F/CMVSS Noncompliance Recall

56340 Tire and Certification Label Incorrect

Reference Number: N162056340
GWM Number: 2056340
Revision Description: Bulletin 56340 has been revised to include the customer notification letter and update the condition paragraph. Please discard all previous copies of bulletin 56340.

Release Date: August 2016
Revision: 01

4564077

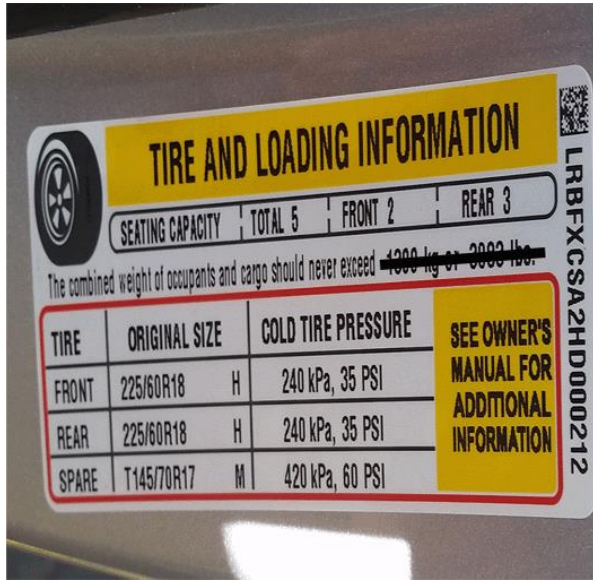
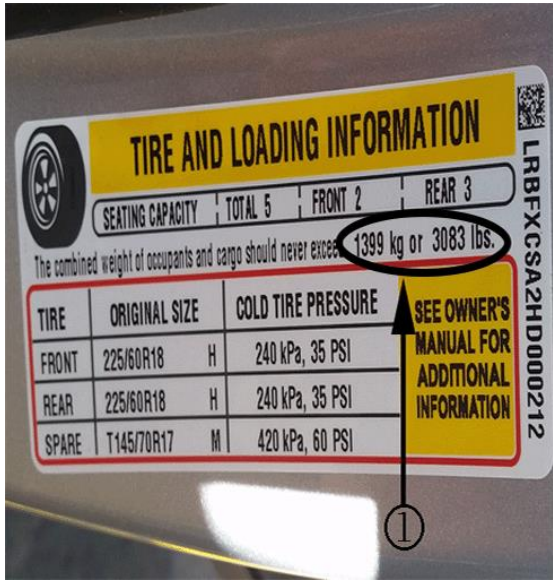
- If the tire and loading information label has the overlay label (1) applied, or already has the correct label installed (432 kg or 952 lbs) no further action is required for this label. Continue to step 6.
 - If the tire and loading information label has NOT had the overlay label (1) applied, continue to step 3.
3. Clean the tire and loading information label with isopropyl alcohol (rubbing alcohol) and a clean shop towel.

4555809

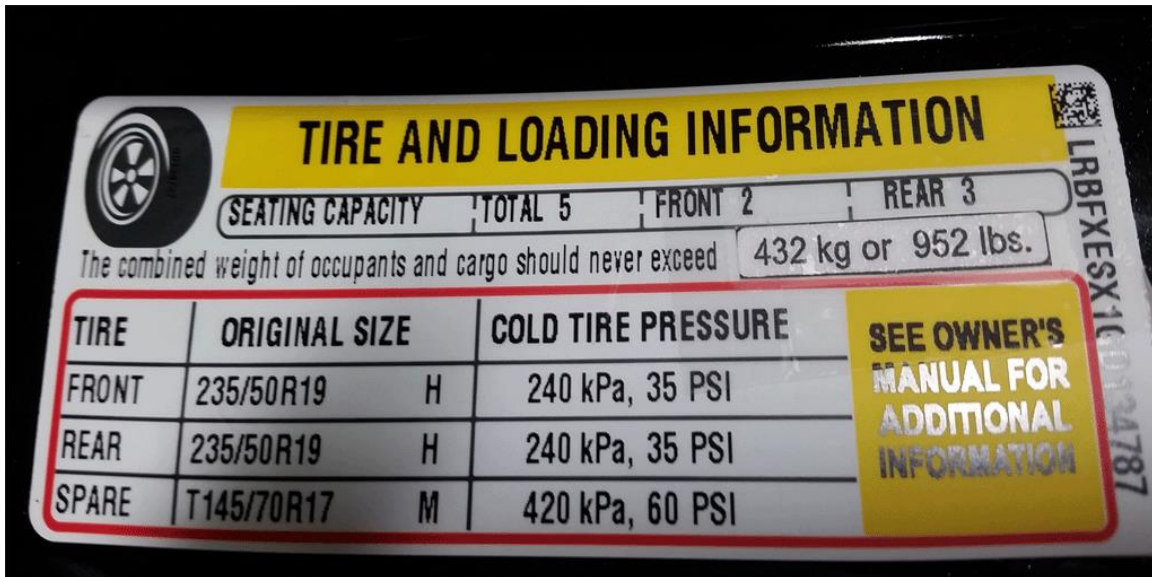
- Perform a single strikethrough of the incorrect weight values (1) with a Sharpie Industrial Permanent Ink marker 13601.

- Install the overlay label over top of the incorrect weight values as shown above. Assure the label is properly positioned before allowing contact with the original label. The overlay label should be installed between the black and red horizontal lines, after the word “exceed”. Do NOT cover the VIN on the right side of the label.

4564060

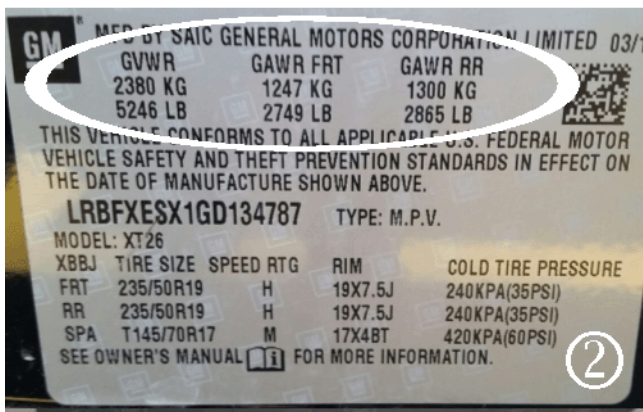
7. Incorrect label information shown (1).

8. Correct label information shown (2).
 - If the correct certification label has been applied (2), no further action is required.
 - If the certification label has NOT been updated (1), continue to step 9.
9. Clean the certification label with isopropyl alcohol (rubbing alcohol) and a clean shop towel.

4564063

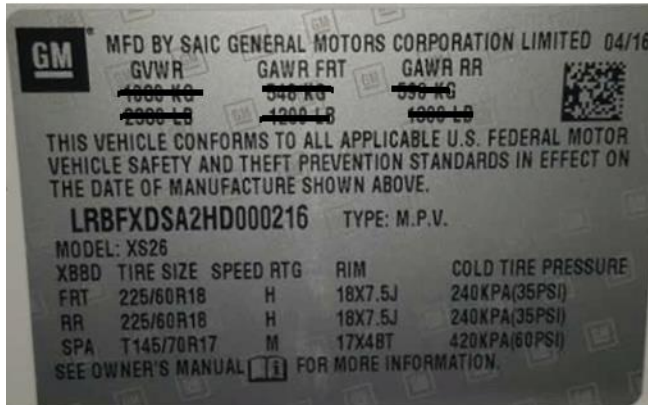
10. Perform strikethroughs of the incorrect values as shown with a Sharpie Industrial Permanent Ink marker 13601.

4564064

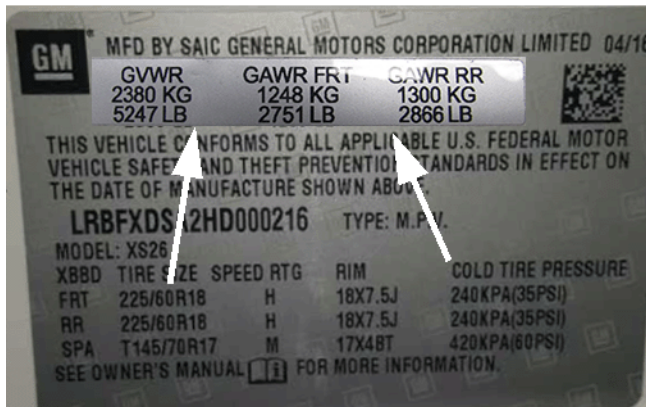
Note: Be sure not to cover any other information on the label besides the GVWR and GAWR weight specifications. The Canada label is similar. Align the overlay label with the left edge of the certification label underneath the GM logo making sure not to cover any other information besides GVWR and GAWR weight specifications.

11. Install the overlay label over top of the incorrect weight values as shown above. Assure the label is properly positioned before allowing contact with the original label. The overlay label should be installed as shown above. Canada label similar.
12. Close the driver door.
13. CALIFORNIA VEHICLES ONLY: Complete a "Proof of Correction" certificate and provide to the vehicle owner upon recall completion.
